CITY OF ALBUQUERQUE

RE: **Lot 2 Block 3 Unit 18, S.A.D. 228**
6612 Cuervo Pl. NW
Grading and Drainage Plan
Engineers Stamp Date 10-28-19 (D10D003B2)

Based upon the information provided in your submittal received 10/28/19, this plan cannot be approved for Grading Permit until the following comments are addressed

JOHNSON (MIKE SANCHEZ) - 6612 CUERVO GRADING & DRAINAGE PLAN

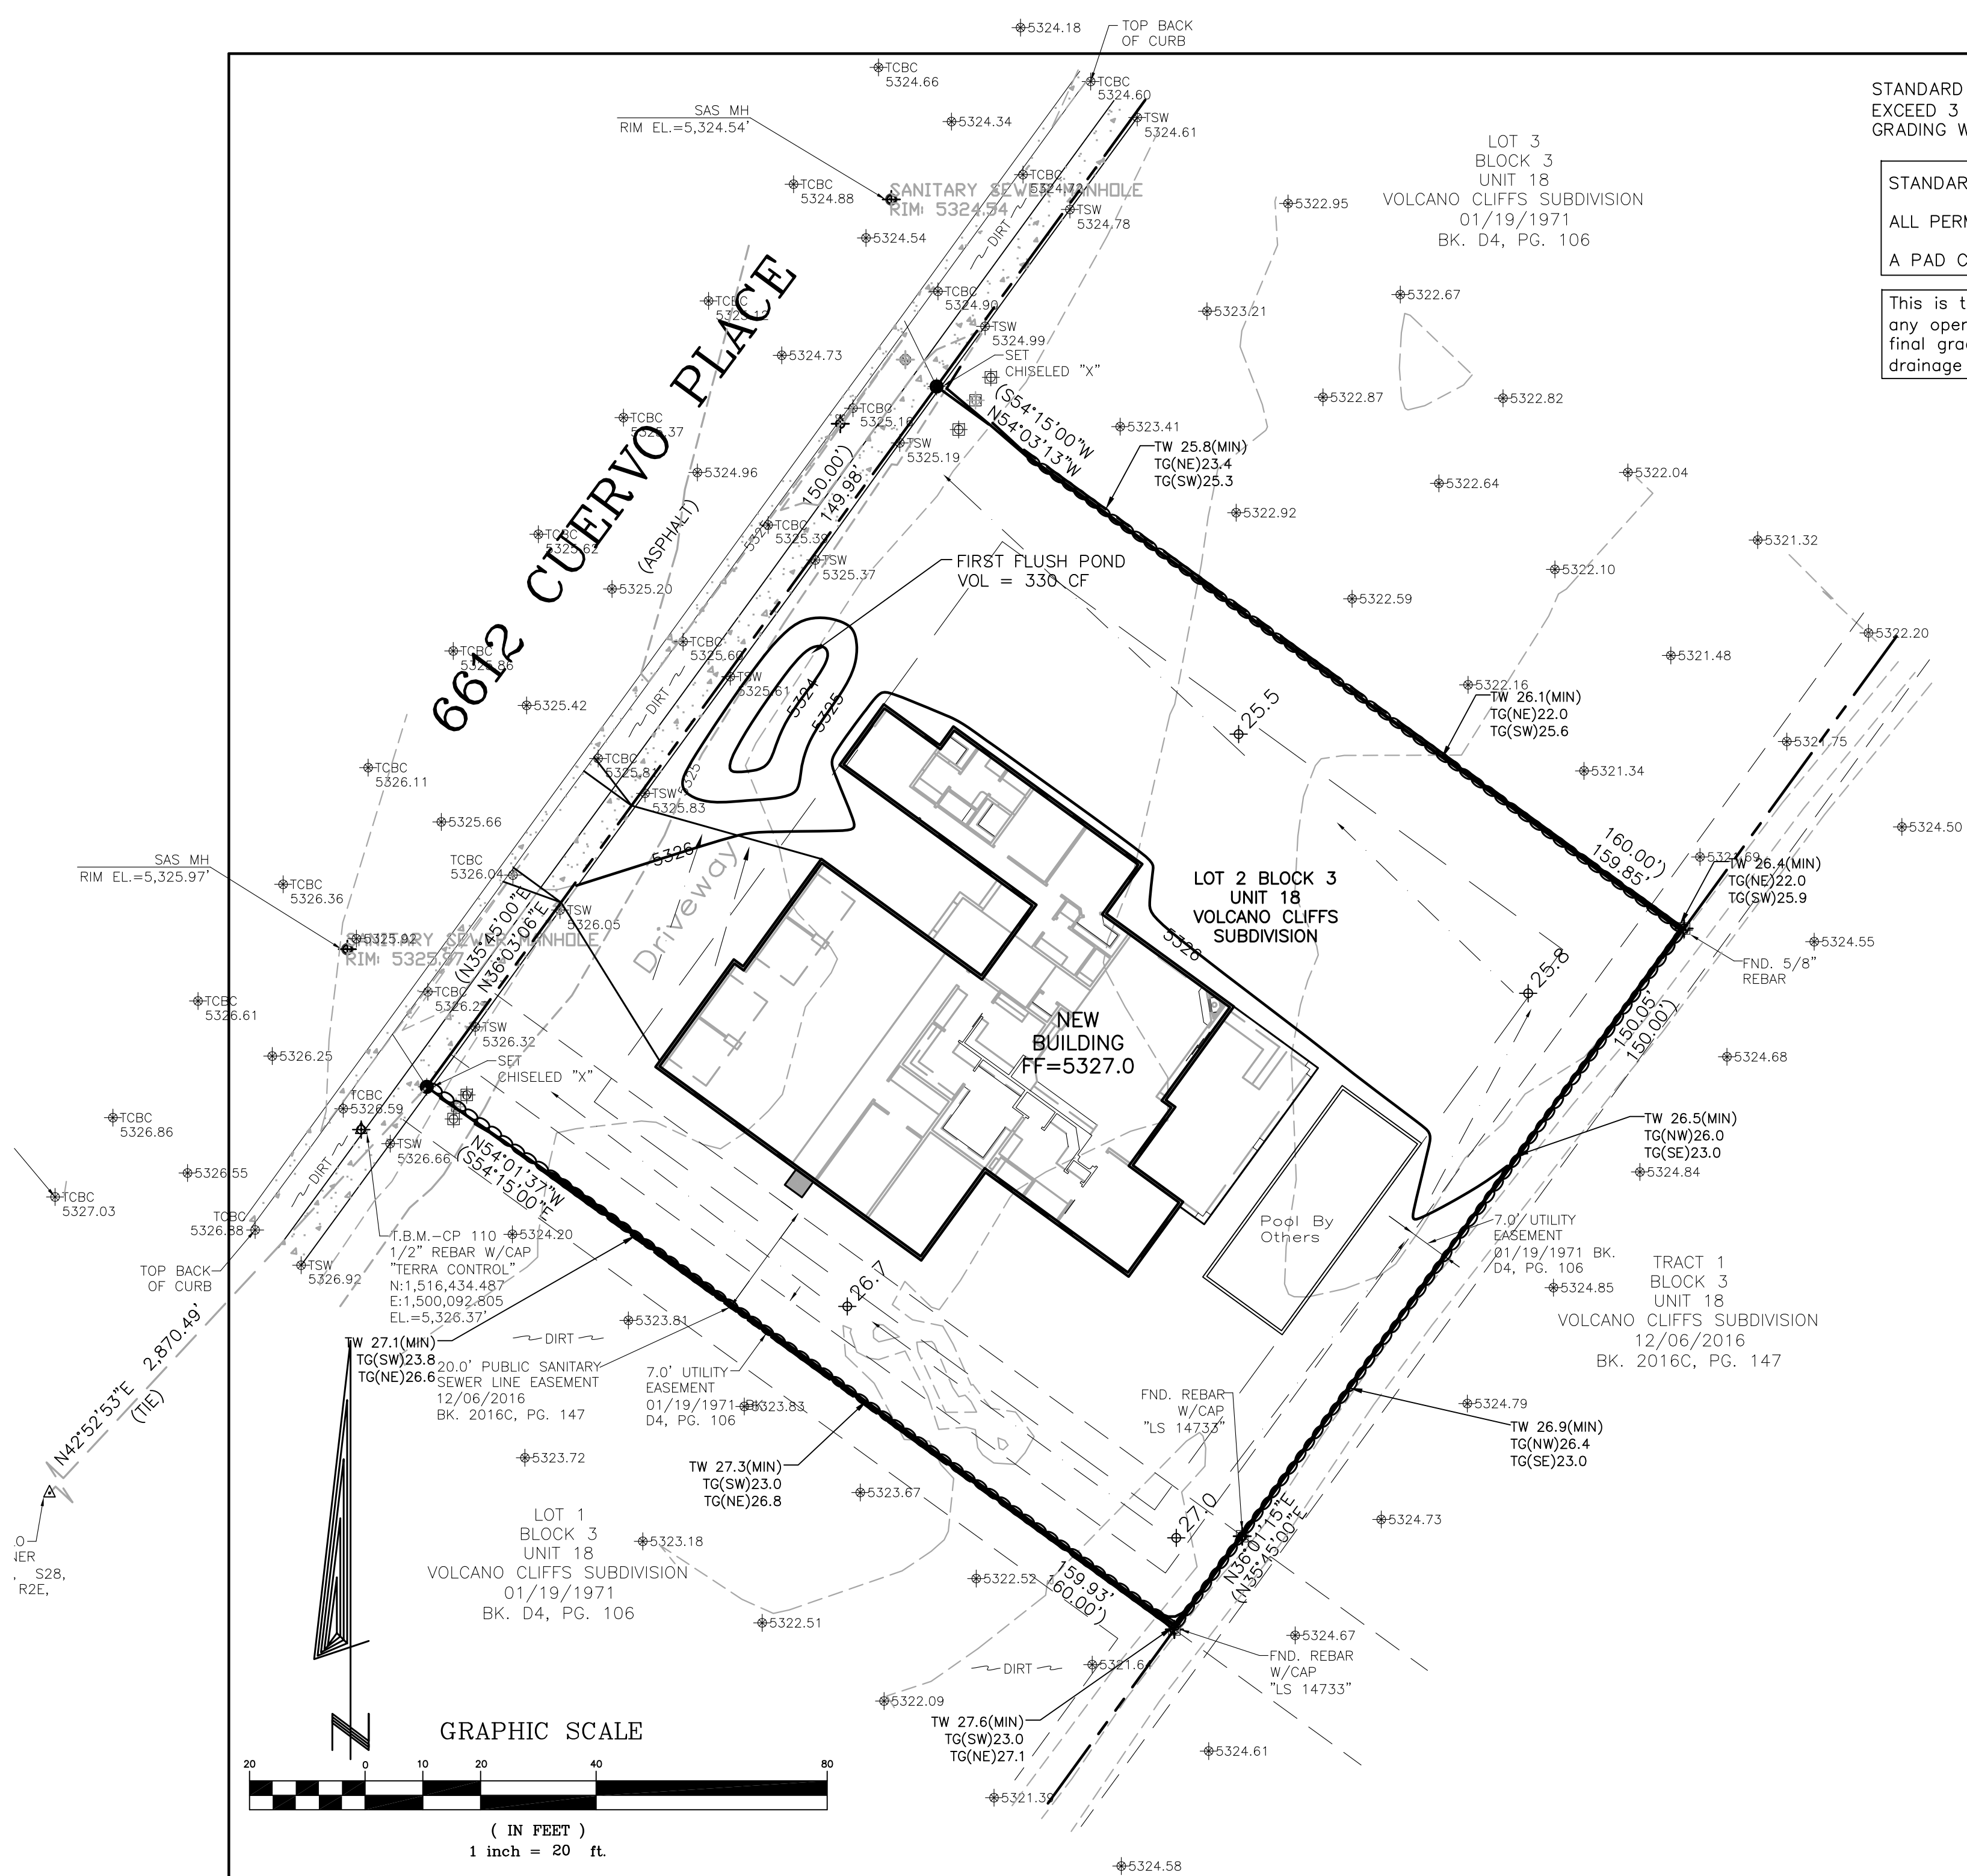
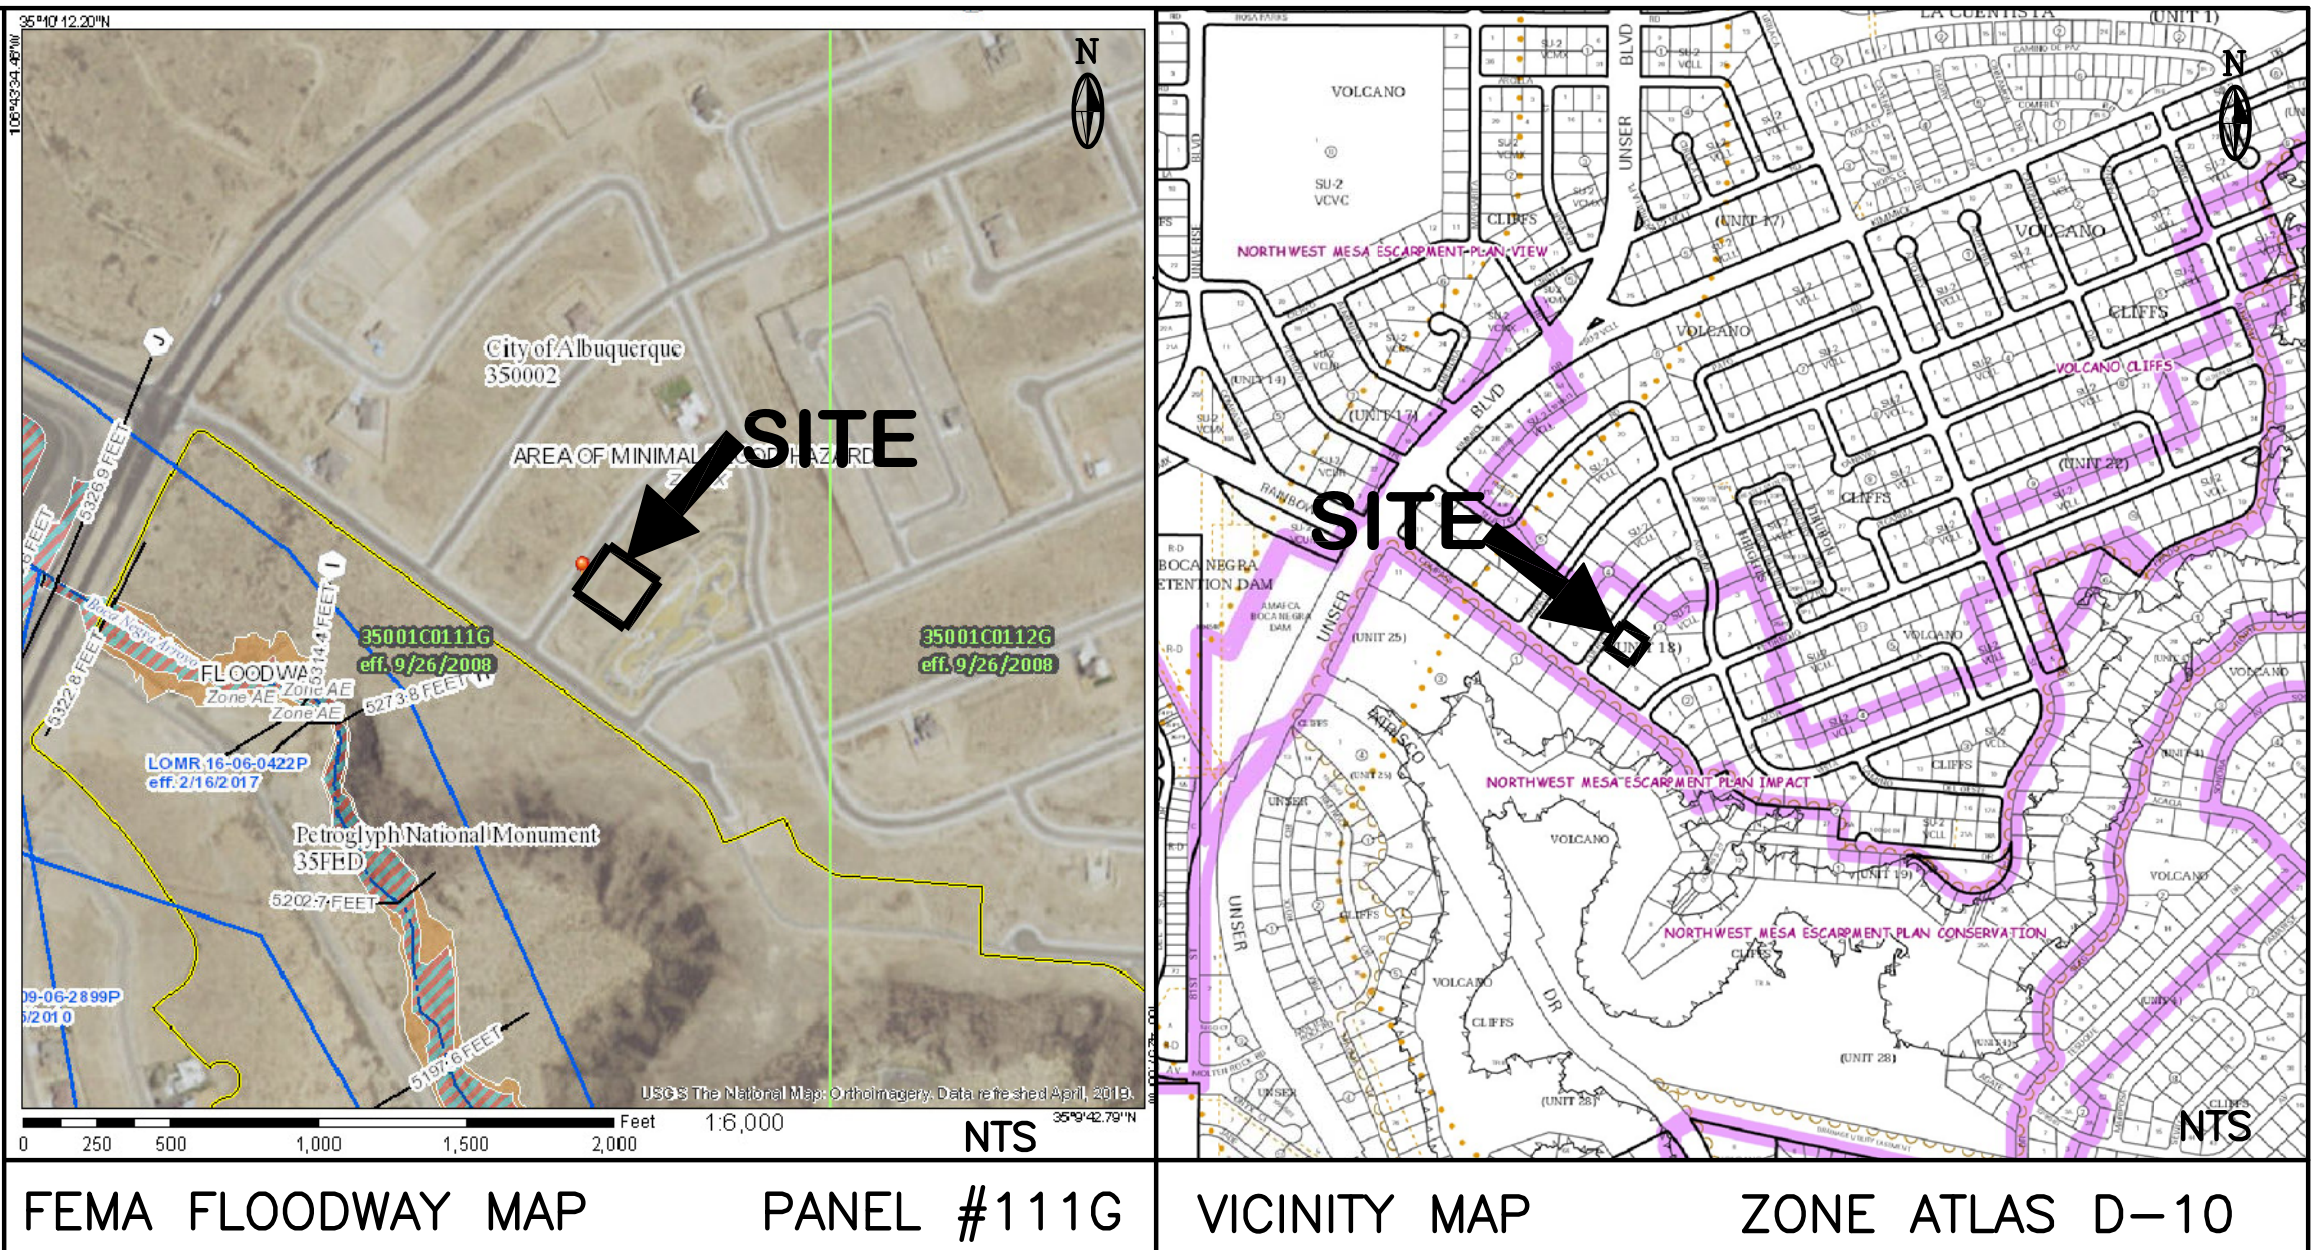
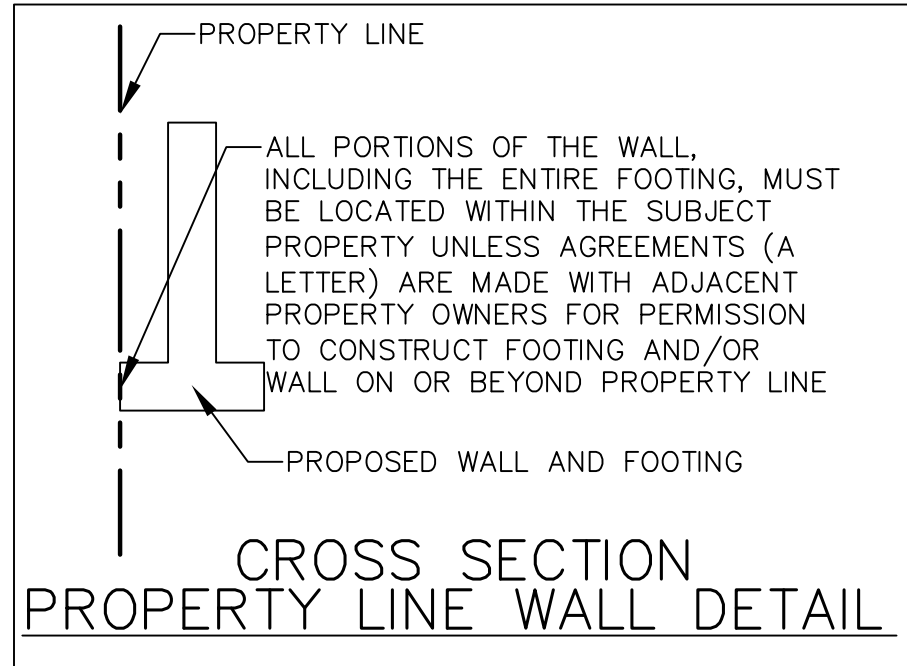
- Provide the amount of treatment C for this lot. Land treatment C is land compacted by human activity, minimal vegetation gravel or rock on landscaping etc.

Prior to Building permit approval a Pad Certification will be required, provided by the Engineer signed and dated or a registered Land Surveyor with as-build elevations.
